# EMISSION RECALL BULLETIN

Subject: **Emission Recall D18R3**  
**GHG14 DD Platform Model Years 2013-2015 Software**  
**Reprogramming For California Inspection and Maintenance**

**Figure 1 – DiagnosticLink® Identification Screen**

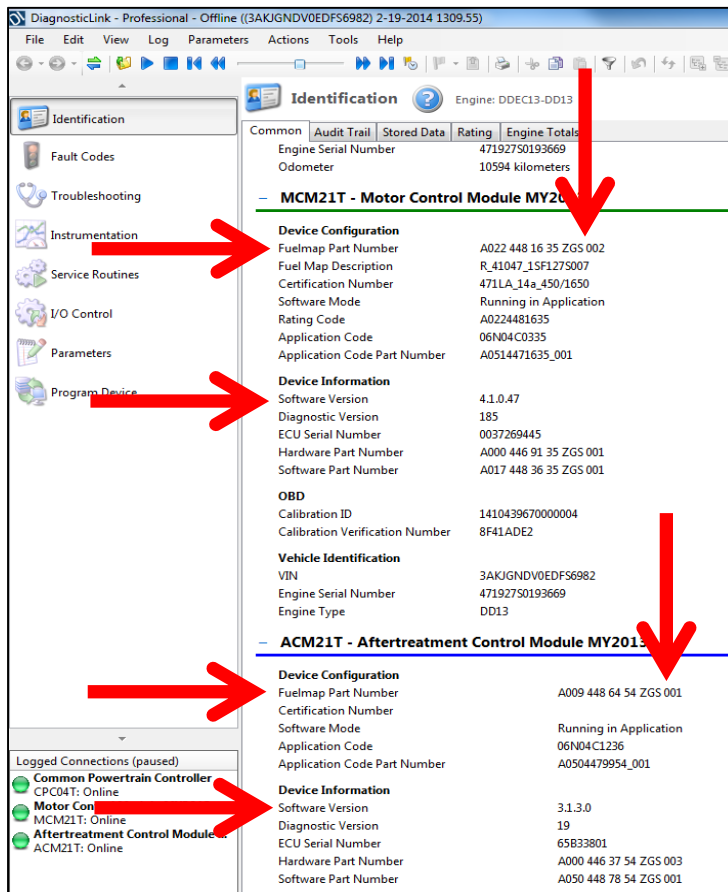
5. On the Identification screen, check the current MCM and ACM software and fuel map level. Listed below are the **MINIMUM** levels required. See Figure 1 for an example of the Identification screen for the MCM and ACM.
  - a. MCM **4.7.0.0 software** and fuel map version **ZGS 002**, except for these ratings:
    - i. DD13 380/410/1450 1-BOX for Oshkosh, fuel map p/n A0364483035 ZGS 001
    - ii. DD13 435/1550 1-BOX for Oshkosh, fuel map p/n A0364483135 ZGS 001
    - iii. DD13 450/1550 Two-box for MCI, fuel map p/n A0364482735 ZGS 001
    - iv. DD13 450/1450/1650 1-BOX, fuel map p/n A0294487935 ZGS 003
    - v. DD15AT 455/1550/1750 1-BOX, fuel map p/n A0304480035 ZGS 003
  - b. ACM **5.57.0.0 software** and fuel map version **ZGS 003**

6. Is the software level for the MCM and ACM less than, equal to, or higher than the minimum software levels listed in step 5? All modules must meet the **MINIMUM** requirements. For example, in Figure 1, MCM software 4.1.0.47 and ACM software 3.1.3.0 are both less than the minimum levels of 4.7.0.0 and 5.57.0.0, and thus would require programming, regardless of fuel map ZGS version.
  - a. If less than the minimum software levels, proceed to step 8.
  - b. If equal to the minimum software levels, proceed to step 7.
  - c. If greater than the minimum software levels, no programming is necessary. Proceed to step 13.

Figure 2 – DiagnosticLink® Identification Screen

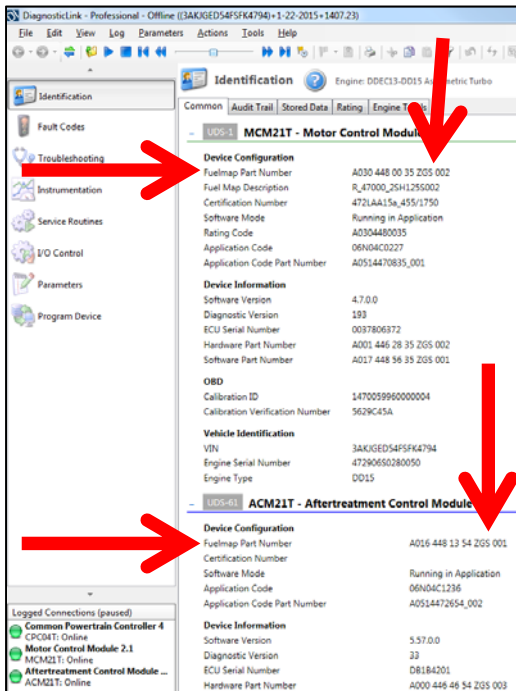
7. Is the fuel map ZGS version level for the MCM and ACM less than, equal to, or higher than the fuel map ZGS revision levels listed in step 5? The MCM and ACM fuel map ZGS version levels must meet the **MINIMUM** requirements. For example, in Figure 2, both the MCM and ACM software levels meet the minimum required of MCM 4.7.0.0 and ACM 5.57.0.0, but the fuel map ZGS version levels of MCM 002 and ACM 001 are less than the minimum levels of MCM 002 (except for five ratings that are different, including the one shown) and ACM 003, and would require programming.
  - a. If less than the minimum fuel map ZGS version levels, proceed to step 8.
  - b. If equal to, or greater than, the minimum fuel map ZGS version levels, no programming is necessary. Proceed to step 13.
